TO: Amy Hodgen (Statutory Planning)
 FROM: Blake Farmar-Bowers (Urban Design)
 DATE: 04 February 2019
 SUBJECT: 626 Heidelberg Rd, Alphington
 The Outer Circle Mews, Heidelberg Road, Access Lane and the Level 1 Terrace.
 APPLICATION NO: PLN17/0703
 DESCRIPTION: Use and development of the land for a mixed use development containing dwellings, supermarket, shops, food and drink premises, office (including medical centres), restricted recreational facility (gym), childcare centre, education centre (primary school) and a place of assembly and a reduction in the car parking requirements and creating access to a Road Zone Category 1 road.

This memo provides comment in regard to The Outer Circle Mews, Heidelberg Road, Access Lane and the Level 1 Terrace only.

Outer Circle Mews

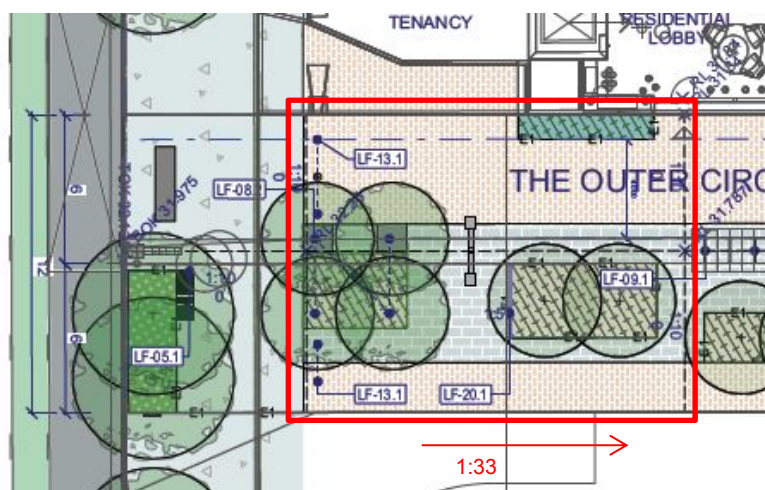
Show the architectural footprint of the Cayden Development (2A) on plan drawings to illustrate the interface with built form.

The northern segment of the Mews has a long fall of 1:33. Given this surface will accommodate movement in various directions the maximum (cross) fall should be 1:40.

Ensure a clear drainage strategy is provided.

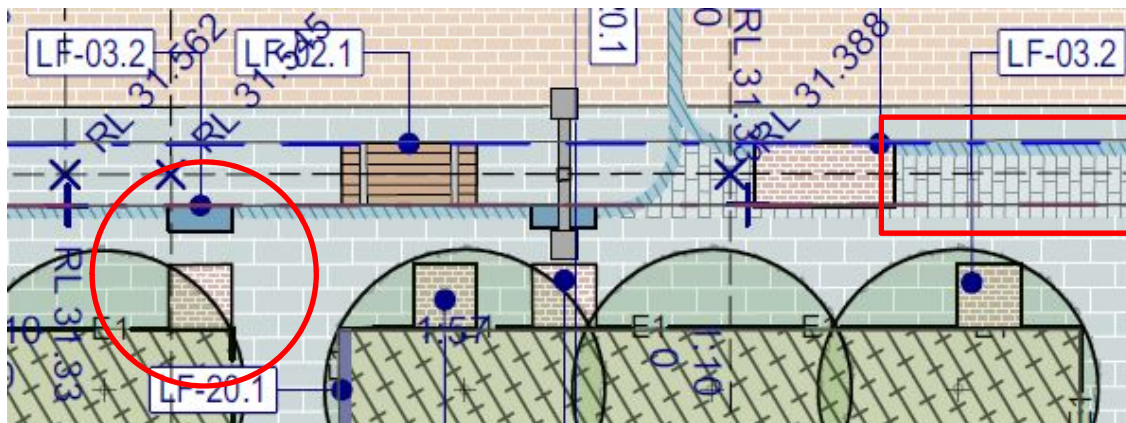
Clarify the pavement anomaly (as noted below).

Provide details of the custom furniture & fixtures (including integration with interpretive inlay)

Provide detail of wind screens.

Clarify code LF8.2.

Clarify if locked bicycles obstruct MFB access.

Clarify pavement type

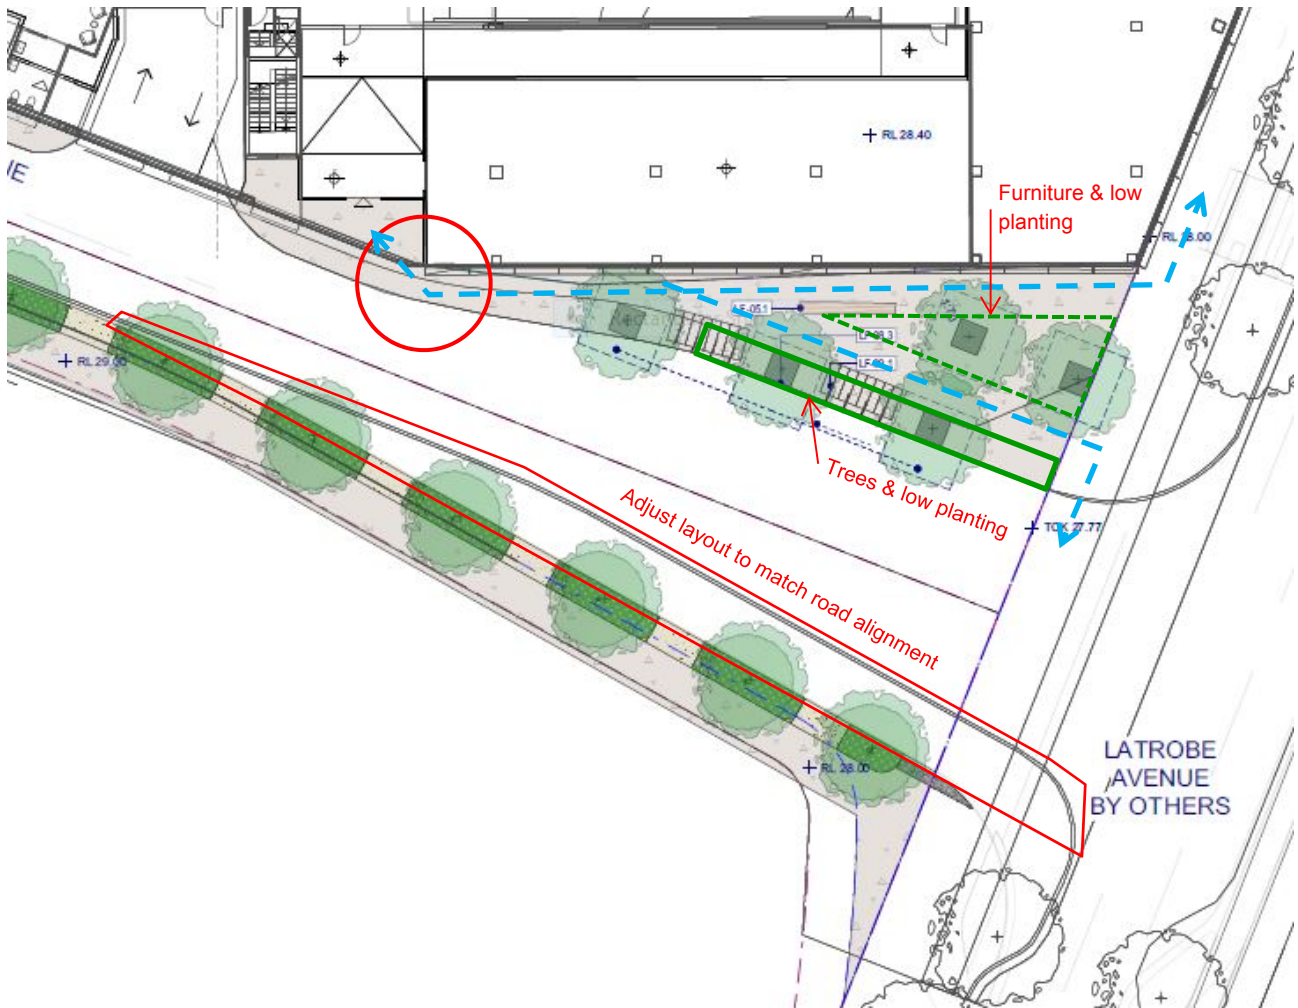
Co-ordinate layout with road alignment, and redesign accordingly (as noted below).

Ensure a minimum 2.5m wide clear path of travel is attained along the building line.

Provide comprehensive levels and grading information.

The Lower Ground Commercial entry has been relocated and sightlines are restricted due to the setback from Mills Boulevard and the adjacent speciality store.

Clarify the dimension of pinch point at the south-west corner of development (as shown below).

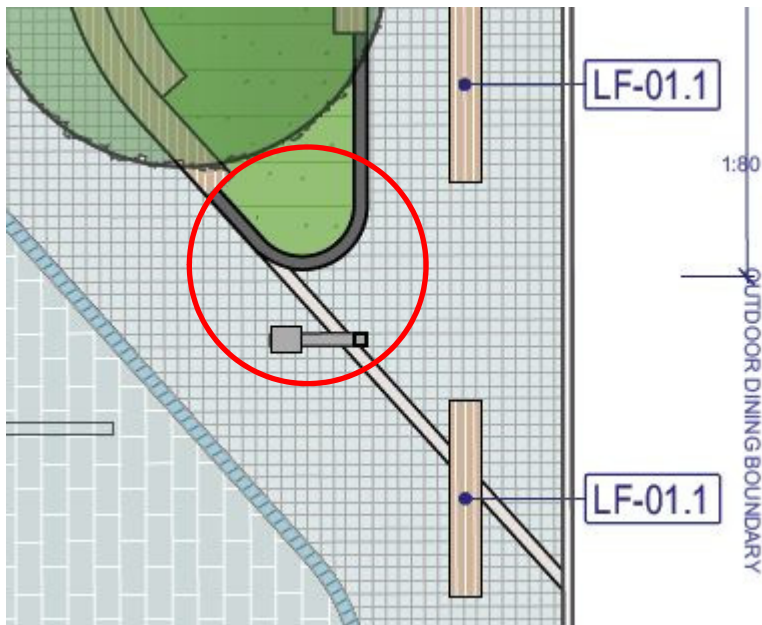
The current bleacher arrangement is not particularly welcoming or comfortable; review of depth of bleachers, provision of back rests, feet clearance etc.

Estimate seating capacity currently being provided to assist in determining desirable quantity.

Show TGSIs on stairway.
